CITY OF ALBUQUERQUE

**RE: The Peaks by Markana Phase II
Conceptual Grading & Drainage Plans
Engineer's Stamp Date: 02/2022
Hydrology File: B18D029**

DRAINAGE AND TRANSPORTATION INFORMATION SHEET (REV 6/2018)

SHEET NUMBER:
C-100

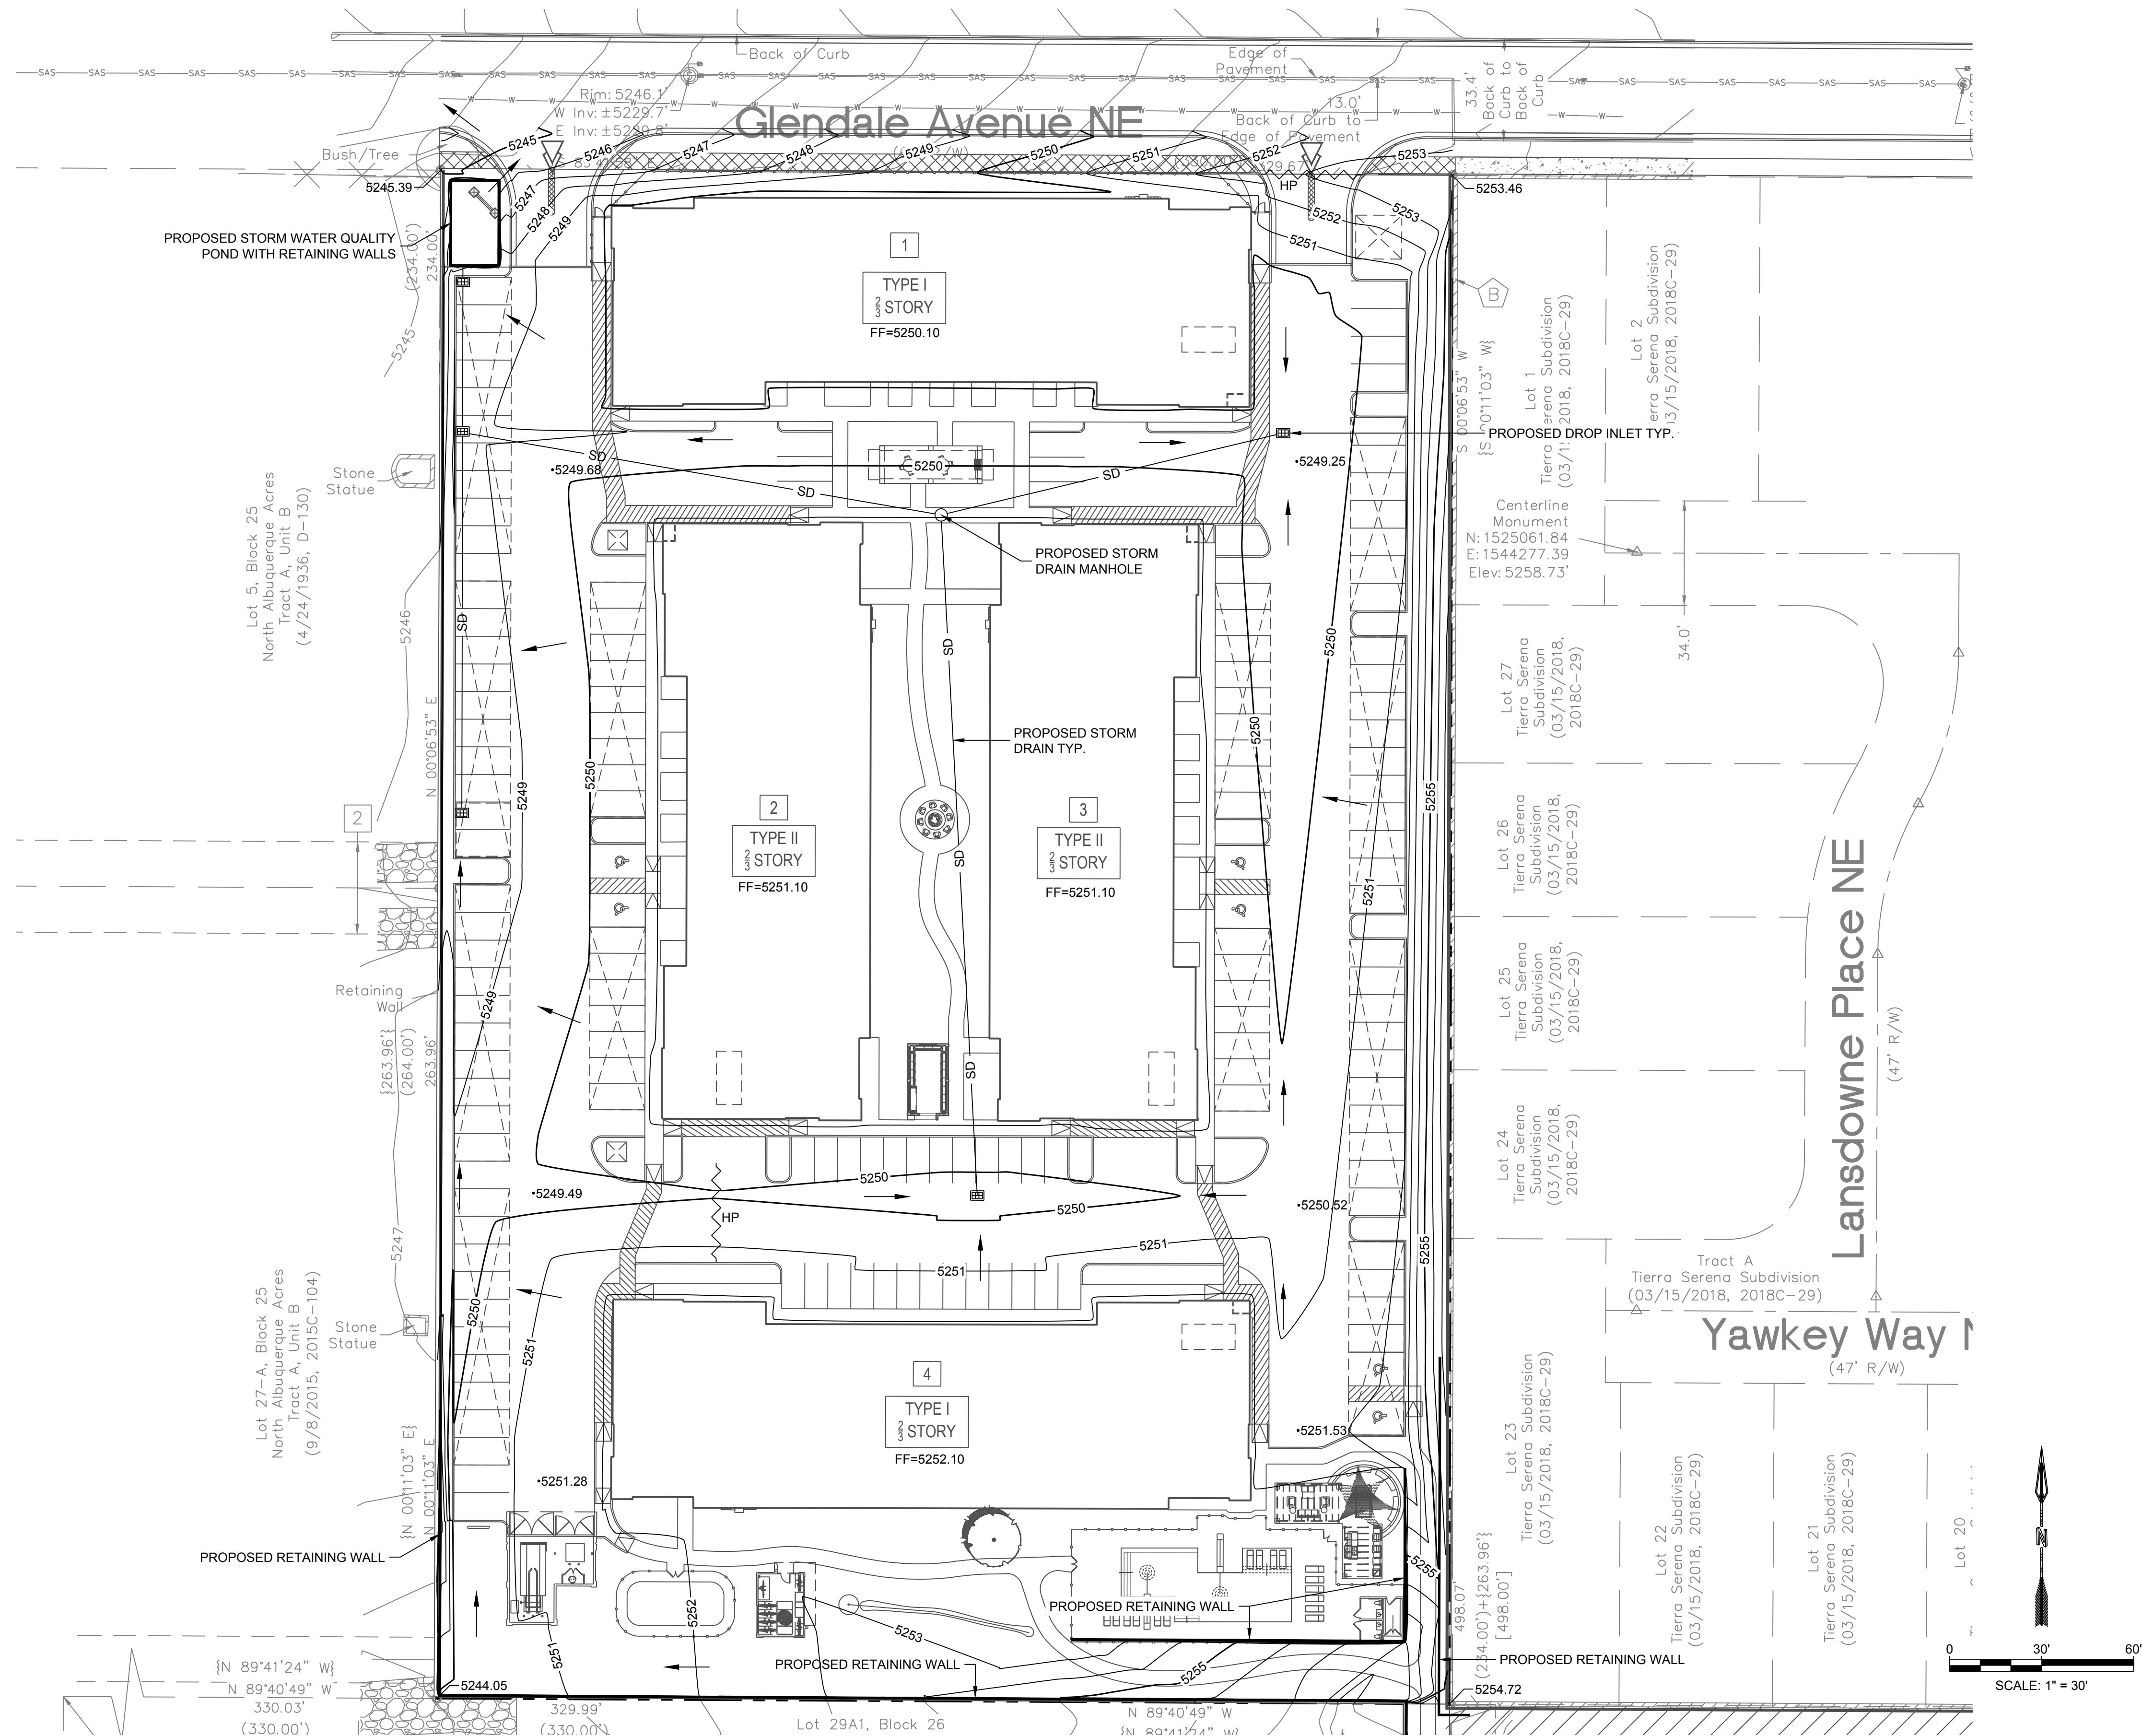
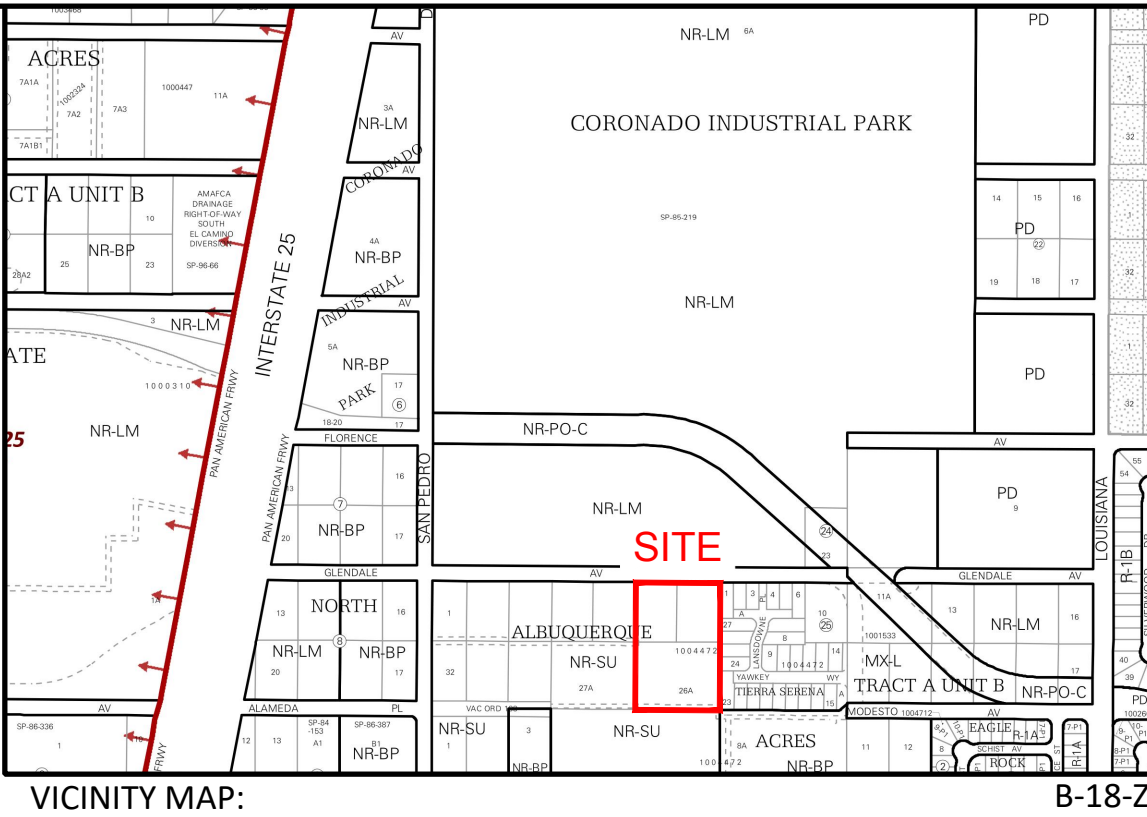
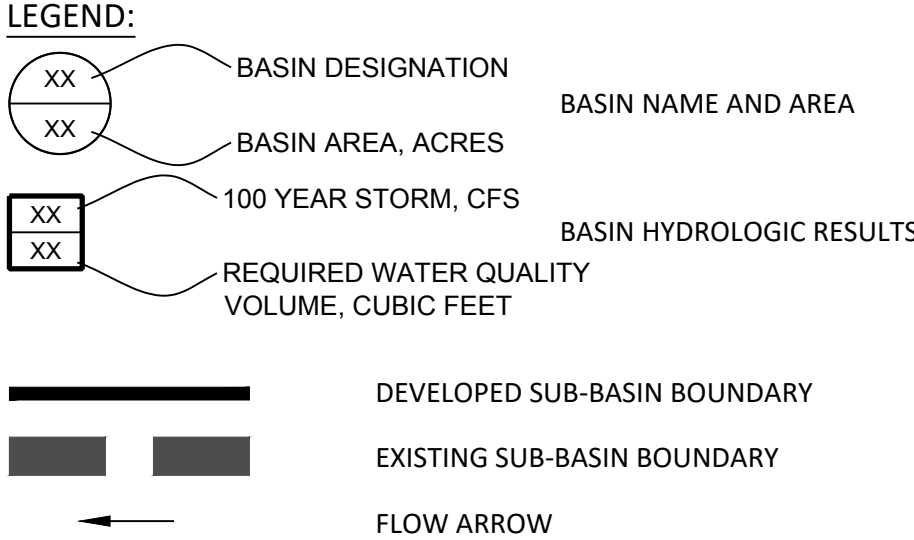
1. According to the NAA DMP, this project is within two Drainage Areas 115.0 & 116.21. Since the proposed site plans to drain to Glendale Ave, the project must a hear to allowable flows for Drainage Area 115.0. This drainage area has an allowable discharge of 2.15 cfs/ac. Also, this means to calculate it will be only the north half of the development. So this project is 3.8 ac. That means the allowable discharge is 3.8 ac * 2.15 cfs/ac = 8.17 cfs.

This all being said, it looks like underground detention facility. The outfall, there are two paths:

- a. Install a storm pipe in Glendale Ave that goes east and discharges into the La Cueva Channel. Possible conflict with existing sanitary sewer.

- b. Install a storm pipe in Glendale Ave that goes west to San Pedro then turns north and connects to an existing storm drain that outfalls to La Cueva Channel.

- c. Provided a retention pond (100 year-10 day volume). This will have to be underground.
